STATE OF NORTH CAROLINA
DEPARTMENT OF TRANSPORTATION

February 15, 2012
Revised March 15, 2012

SUBJECT: **Application for Section 404 Individual Permit, Section 401 Individual Water Quality Certification, and Randleman Lake Buffer Authorization** for the proposed improvement of Greensboro-High Point Road (SR 1486-SR 4121) from US 311 Bypass (future I-74) in High Point to Hilltop Road in Greensboro, Guilford County, Division 7. Federal Aid Project No. STP-4121(1), State Project No. 8.2491602, WBS Element No. 34802.1.1, TIP No. U-2412A&B/U-2524AE.

PROJECT REFERENCE NO. U-2412B		SHEET NO. 17	
ROADWAY DESIGN ENGINEER		HYDRAULICS ENGINEER	
INCOMPLETE PLANS DO NOT USE FOR A/CQUISITION			
PRELIMINARY PLANS DO NOT USE FOR CONSTRUCTION			
Florence & Hutcheson, Inc. 121 WEST TRADE STREET SUITE 1950 CHARLOTTE, NC 28202 N.C. License No. P-1234

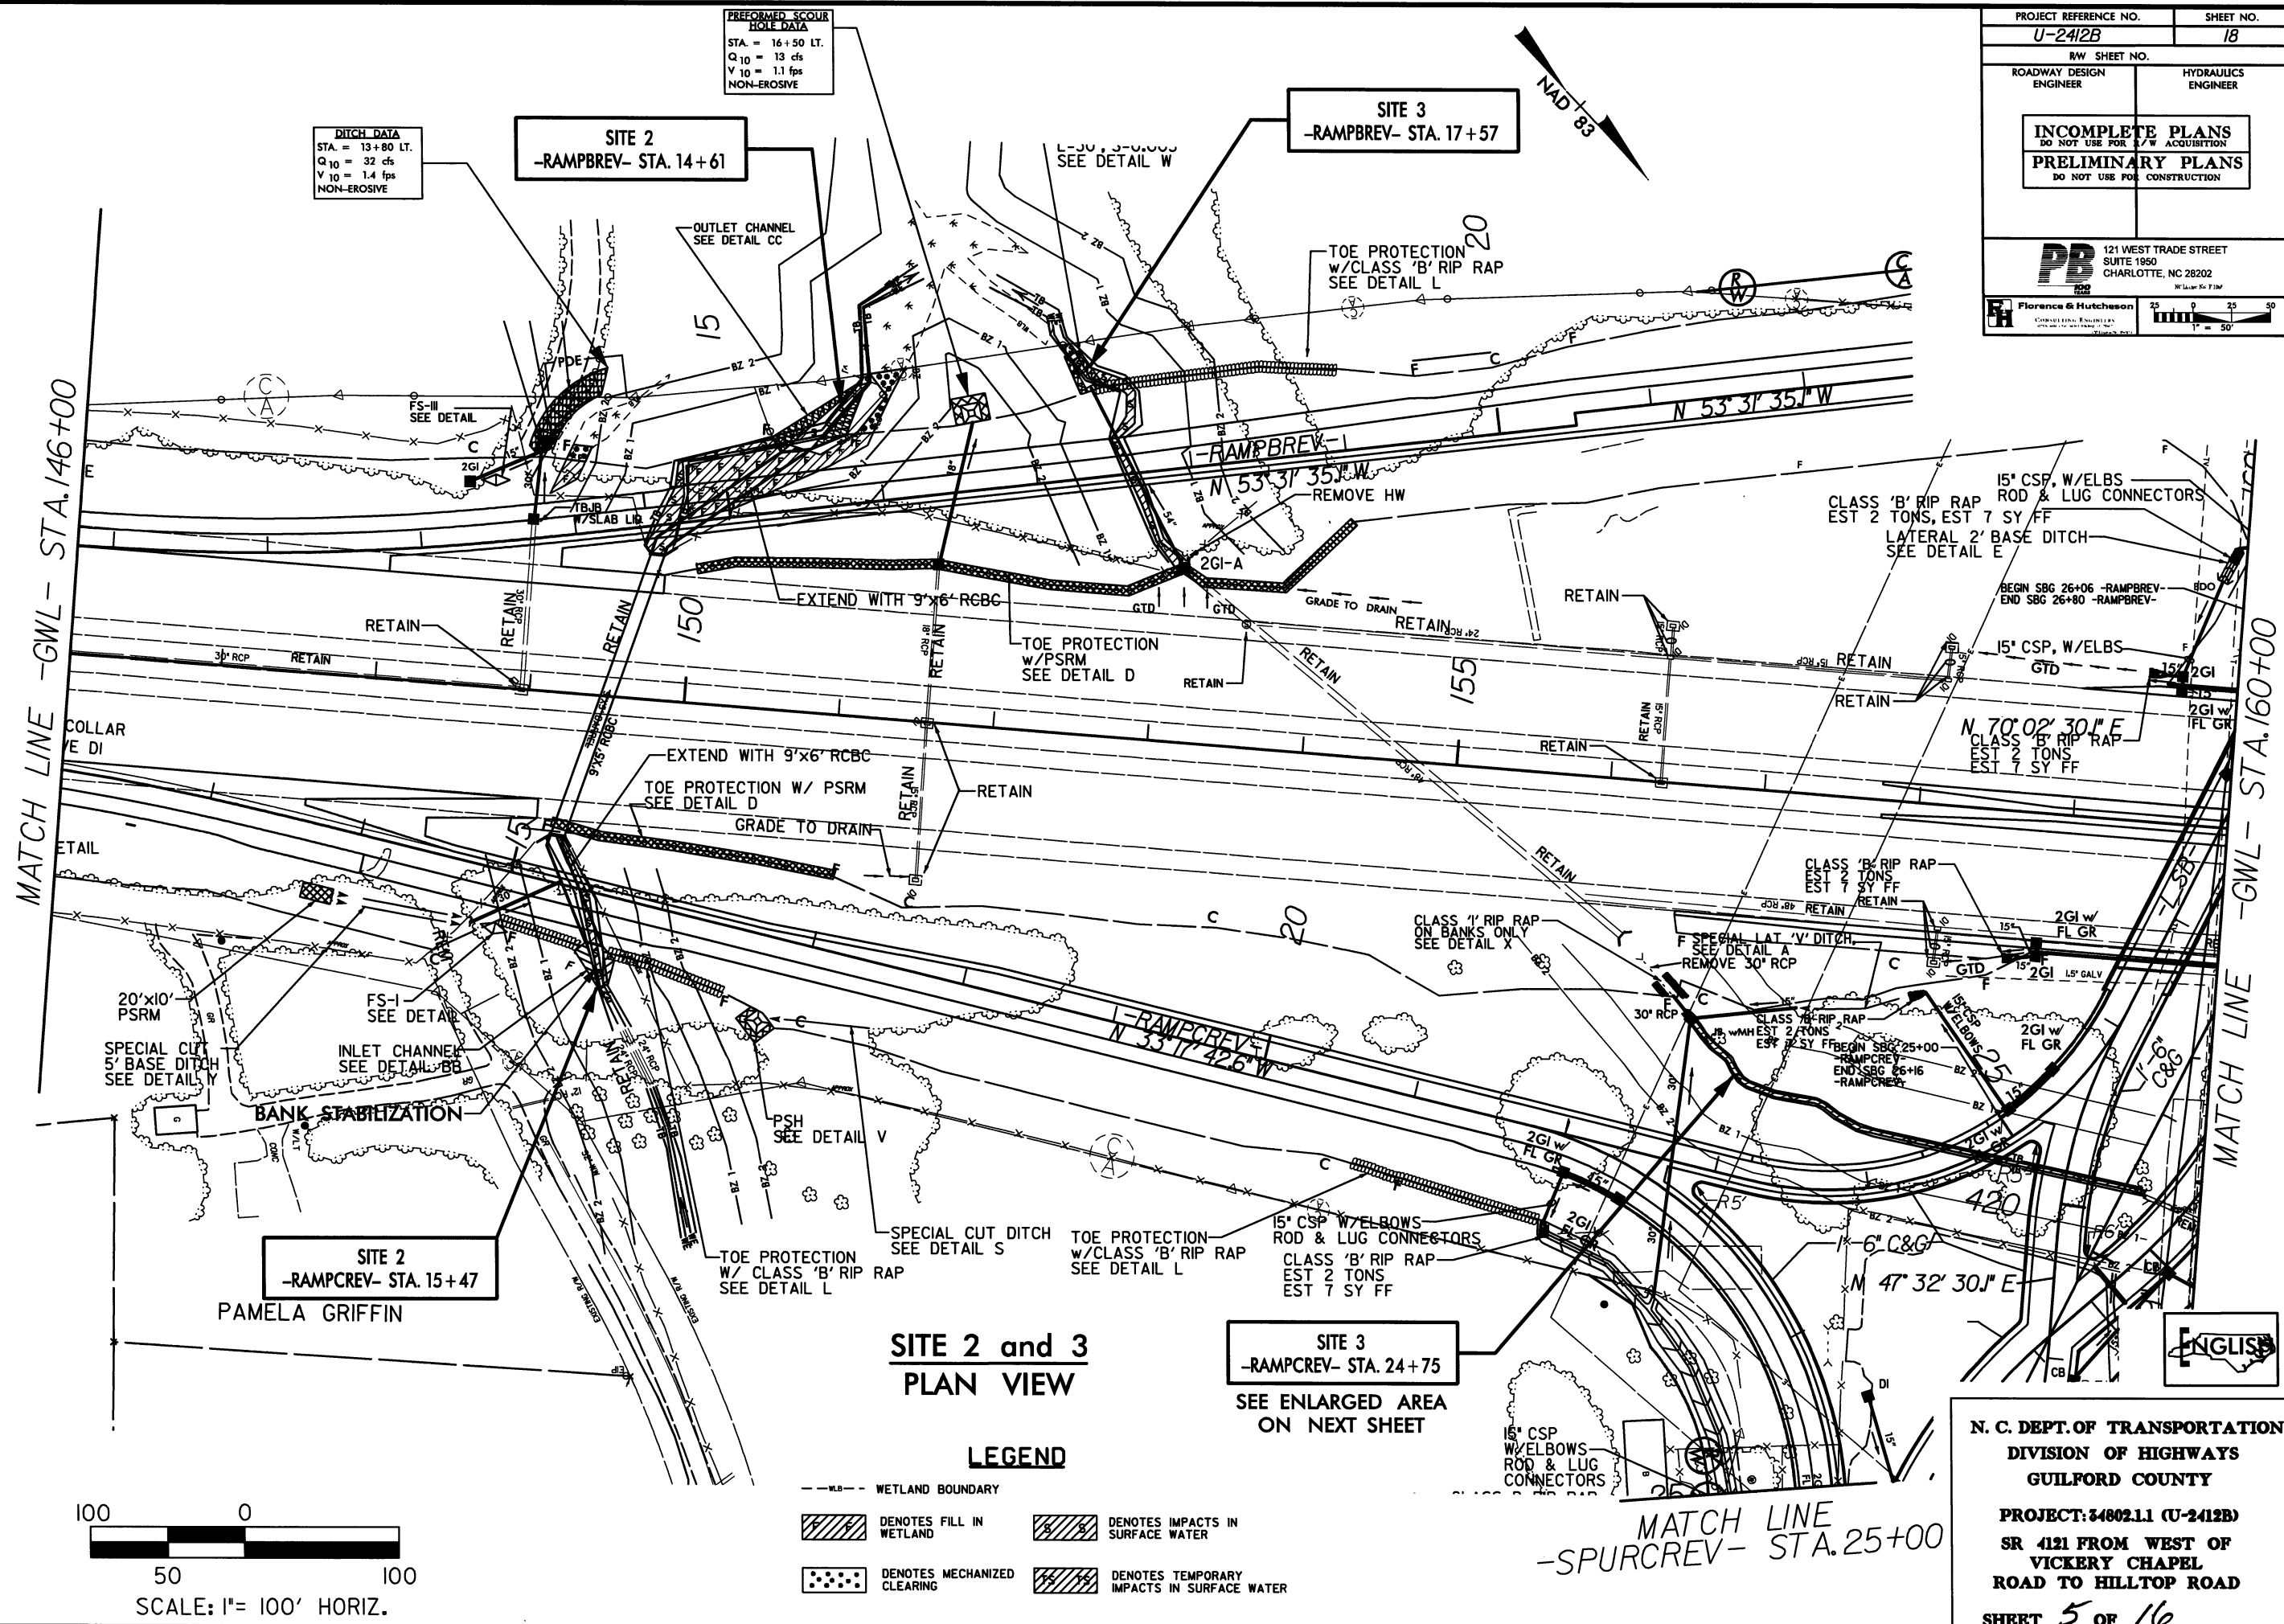
1. For the lower portion of the grass swale (L 399+00 to 403+00 LT) at NE quadrant, roadway has super to the right and no onsite pavement runoff is collected. Its main function is to convey the offsite runoff. The upper portion of the grass swale (L 403+00 to 406+00 LT) does not collect any offsite drainage and provides treatment for onsite pavement runoff (with 100' per acre criterion satisfied). DWQ indicated that the treatment for offsite runoff is not required.
2. Provide additional documentation or explanation regarding stormwater conveyance through buffer on SWMP and buffer drawings.
3. All pipes for stormwater conveyance through buffers are considered mitigable impacts.

PROJECT REFERENCE NO. U-2412B		SHEET NO. 18	
RW SHEET NO.		HYDRAULICS ENGINEER	
ROADWAY DESIGN ENGINEER			
INCOMPLETE PLANS DO NOT USE FOR ACQUISITION			
PRELIMINARY PLANS DO NOT USE FOR CONSTRUCTION			
121 WEST TRADE STREET SUITE 1950 CHARLOTTE, NC 28202 NO SCALE FOR PDS			
Florence & Hutcheson

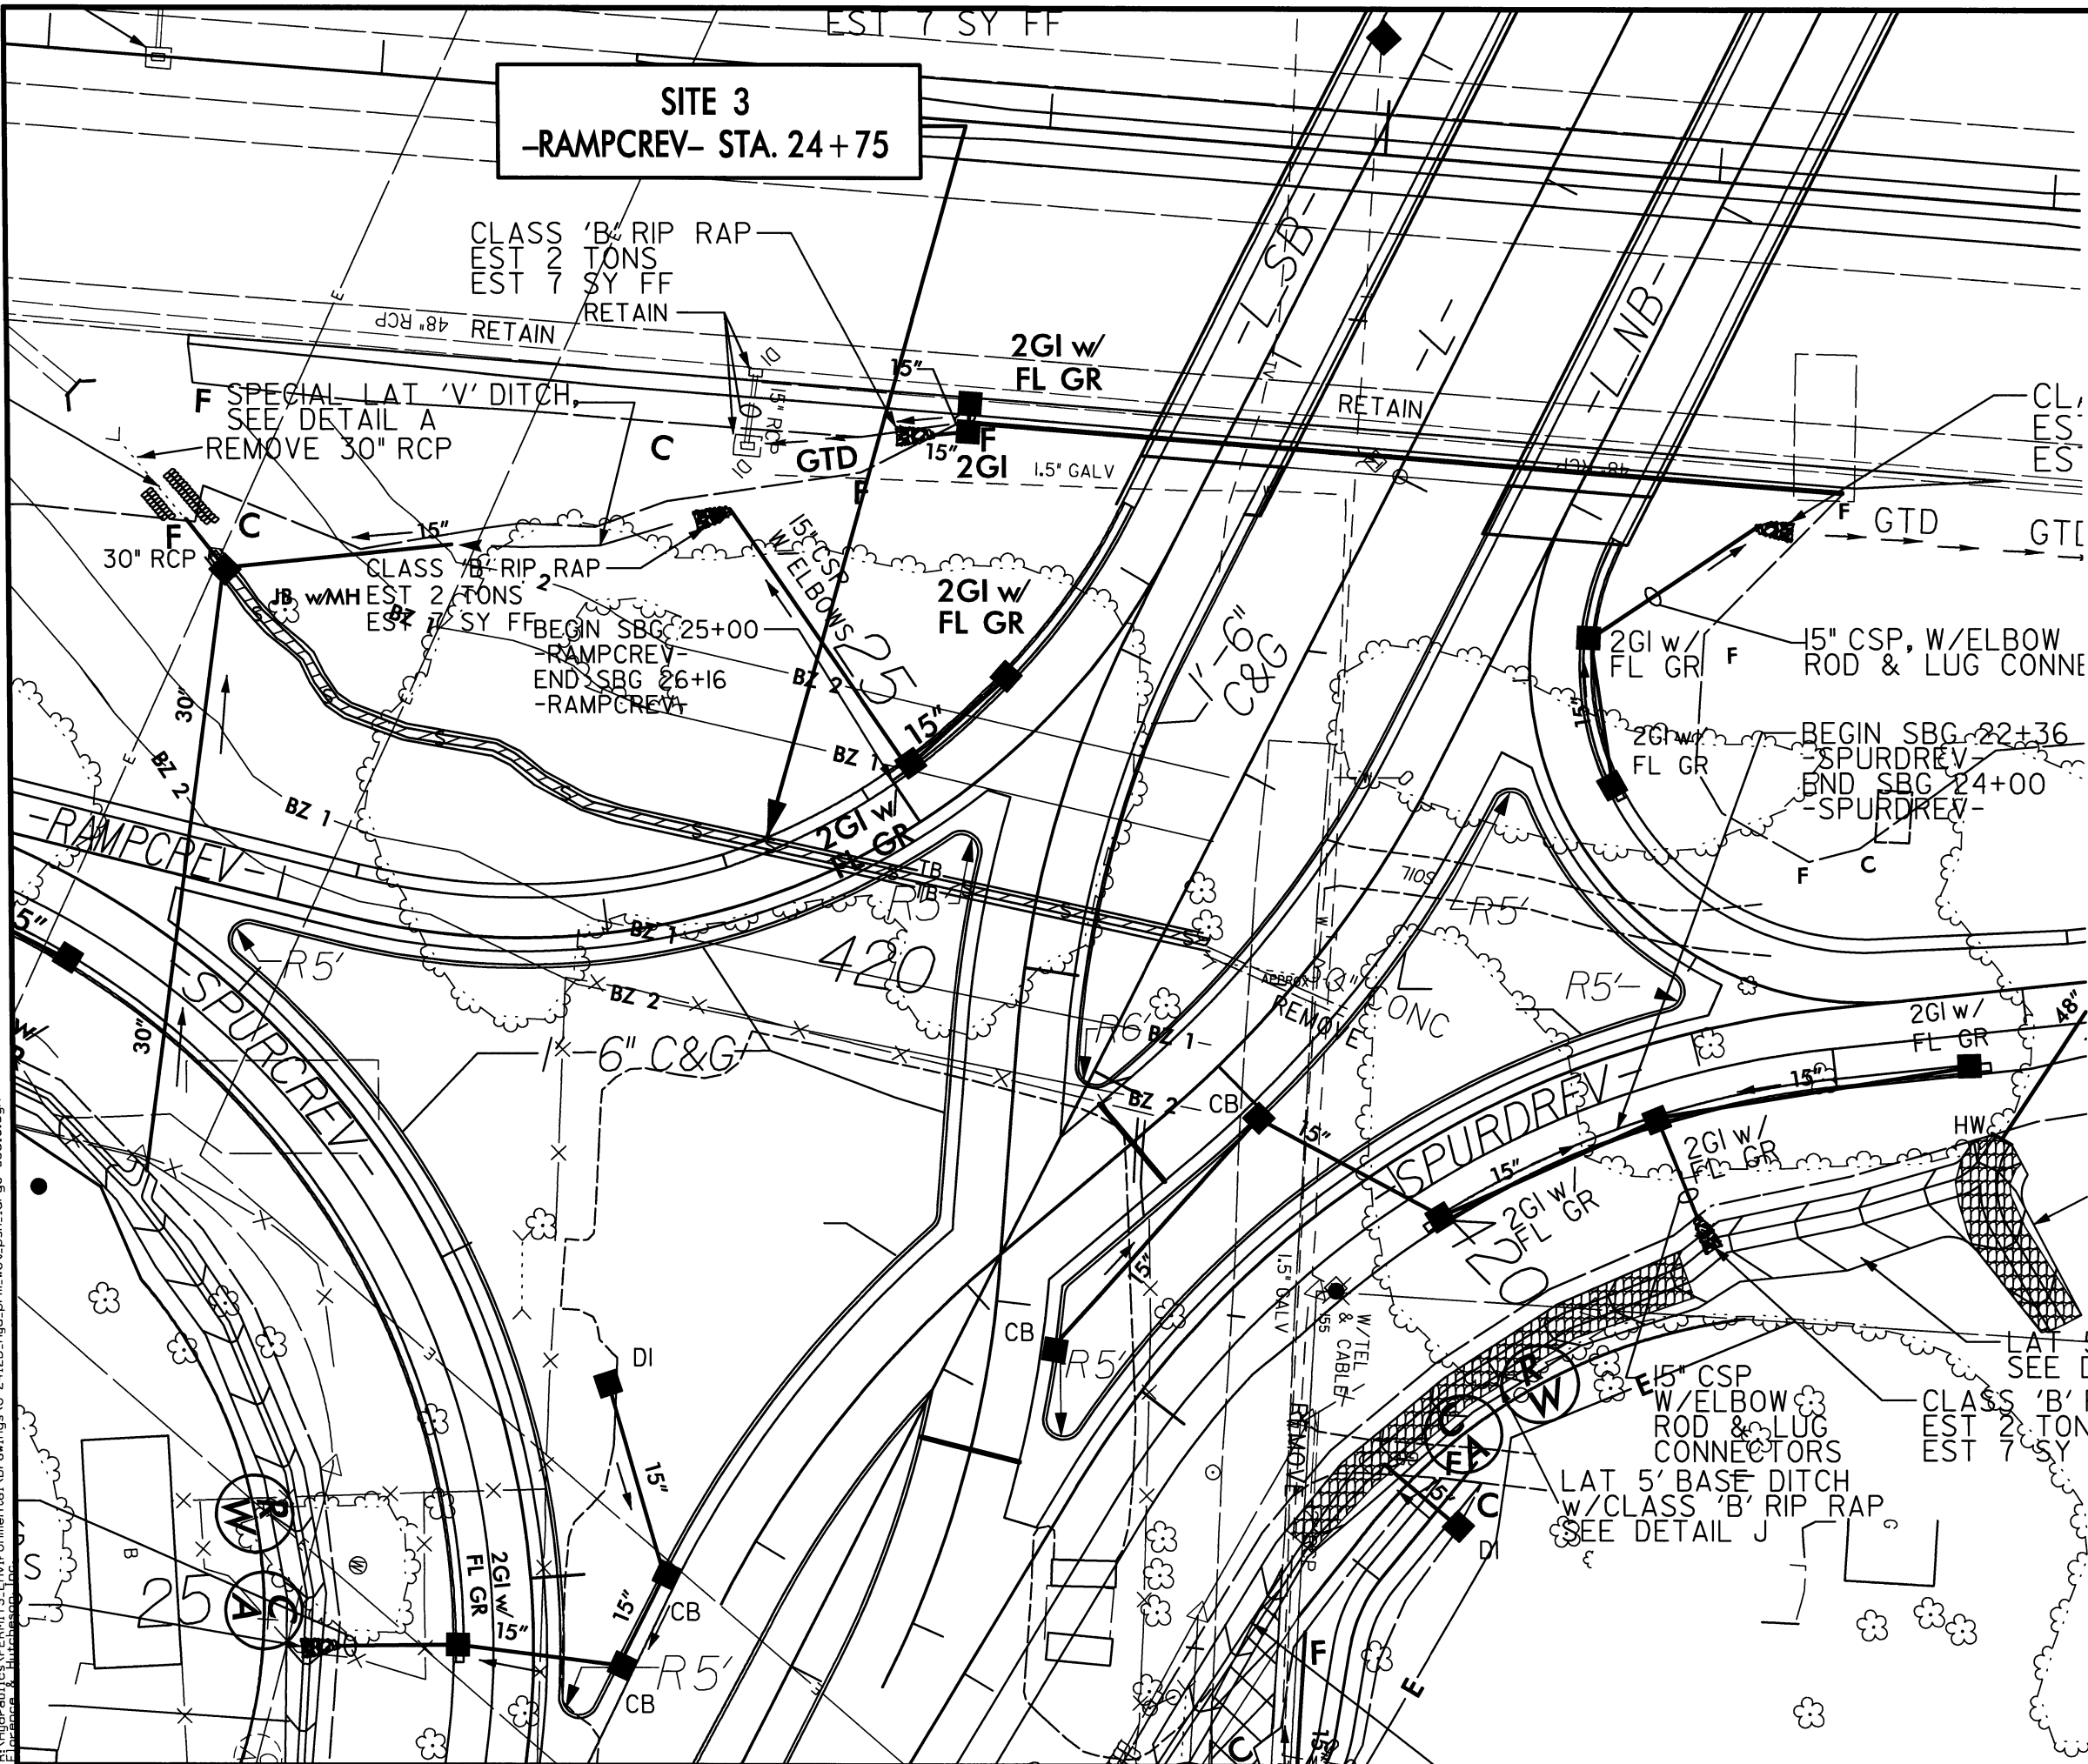
1. Combine Site 2 with Site 4 and label as Site 2 since they are along the same stream.
2. As indicated in SWMP for BMP at -RAMPB- 14+00 LT, F&H explained that the storm drain outlet pipe cannot daylight without a tail ditch. This tail ditch (0%) with rip rap (width from 5' to 15') will dissipate energy to provide a non-erosive diffused flow before entering wetland and buffer.
3. For Site 4, the buffer impact for the 30" pipe to the box culvert is mitigable.
